SUPPLEMENTAL RESPONSE TO REQUEST FOR ADDITIONAL INFORMATION

APR1400 Design Certification

Docket No. 52-046

RAI No.: 293-8332
SRP Section: 04.03 – Nuclear Design
Application Section: 4.3.2.2.3
Date of RAI Issue: 11/05/2015

4.3.2.2.3 Expected Power Distributions

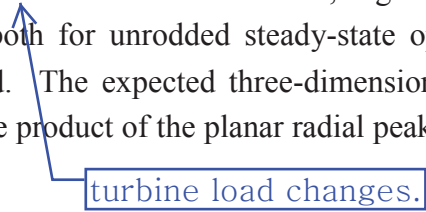
Question No. 04.03-4

Noting that the applicant refers to load-follow operations and transients in DCD Sections 4.3 and 4.4, the staff is concerned that the application lacks much of the information that would

necessary for approving the APR1400 design for load-follow operations. For example, the DCD does not specify the ranges of allowed load-follow power maneuvers (e.g., power swings, power ramp rates), does not detail how load-follow power maneuvers and resulting xenon transients would be controlled with rods versus soluble boron, and does not include analyses of core and system transients associated with load-follow operations. Moreover, the analyses presented in DCD Chapter 15 do not explicitly consider transient load-follow operational conditions in determining the most limiting initial operating conditions for analyzed transients and accidents.

In its response, the applicant should either provide all information necessary for the consideration of load-follow operations or else state that it is seeking approval of the APR1400 design only for defined baseload operations. The applicant should then revise the affected parts of the DCD and its incorporated references accordingly.

APR1400 is basically requested for approval for baseload operation. However, it does not exclude a possible power change necessary for plant operation. For some instances, reactor power needs to be decreased to lower level due to plant conditions. Such plant operations can be divided into two categories, scheduled load maneuver and unexpected load transients such as load rejection. Power maneuvers with schedule load maneuver shall be performed within the limits of Technical Specifications (TS) and the safety analyses are not affected by such operations. Plant conditions during unexpected load transient can be outside of the limits of TS but they are restored automatically or manually after some periods of time. If the limits of TS are not met, power shall be decreased as required in TS.

The capability of the core ~~to follow load transients~~ without exceeding power distribution limitations depends on the margin to operating limits ~~during a load follow operation~~ compared to the margin required for unrodded base-loaded operation. The radial and axial power distributions and estimates of F_q^n and F_r^n are obtained by using ROCS Code System (Reference 5).
